Access Compliance Report

Public Rights-of-Way

(Curb Ramps)

Intersection ID: 47465	Main Street: DOMINION_VILLAGE_DR	Cross Street: DOMINION_GREEN_DR	Location:	N
ADA ID: 750C2294810F	Ramp Type: PerpDiag	Initial Pass/Fail: Fail	Overall Compliance: No	Severity Score: 12.5
Codes/Mitigation Info/Possible Solution		Field Measurements/Component Compliance

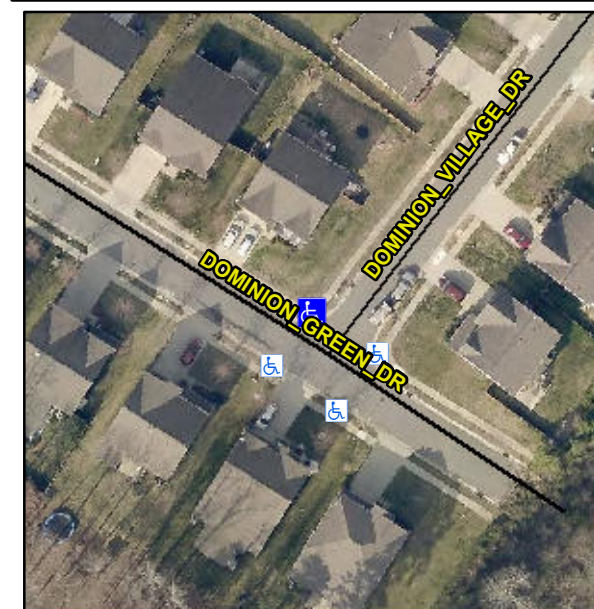
Not Found, R304.2.2

Compliance	Description	Data	Compliance	Description	Data
N/A	Ramp Length (in)	50.0	No	Ramp Slope (%)	11.0
Yes	Ramp Width (in)	48.0	Yes	Ramp XSlope (%)	1.3
N/A	Flare Type LT	N/A	N/A	Flare Type RT	N/A
N/A	Flare Slope LT (%)	N/A	N/A	Flare Slope RT (%)	N/A
N/A	Flare Traversable LT?	N/A	N/A	Flare Traversable RT?	N/A
N/A	Landing Length (in)	N/A	N/A	DWS Provided?	N/A
N/A	Landing Width (in)	N/A	N/A	DWS Contrast?	N/A
N/A	Landing Slope (%)	N/A	N/A	DWS Length (in)	N/A
N/A	Landing X Slope (%)	N/A	N/A	DWS Full Width?	N/A
N/A	Landing Curb? (Y/N)	N/A	N/A	DWS Offset (in)	N/A
N/A	Shared Landing?	N/A			
N/A	Gutter Ponding?	N/A	N/A	Gutter Slope (%)	N/A
N/A	Gutter Lip Ht (in)	N/A	N/A	Gutter X Slope (%)	N/A
N/A	Painted X Walk1?	No	N/A	Painted X Walk2?	No
	X Walk 1 Direction	To SW		X Walk 2 Direction	To SE
N/A	X Walk 1 Width (in)	N/A	N/A	X Walk 2 Width (in)	N/A
	X Walk 1 Slope (%)	0.8		X Walk 2 Slope (%)	1.4
	X Walk 1 X Slope (%)	2.1		X Walk 2 X Slope (%)	0.3

Remove & Replace Curb Ramp With Two New Directional Ramps or Equivalent.
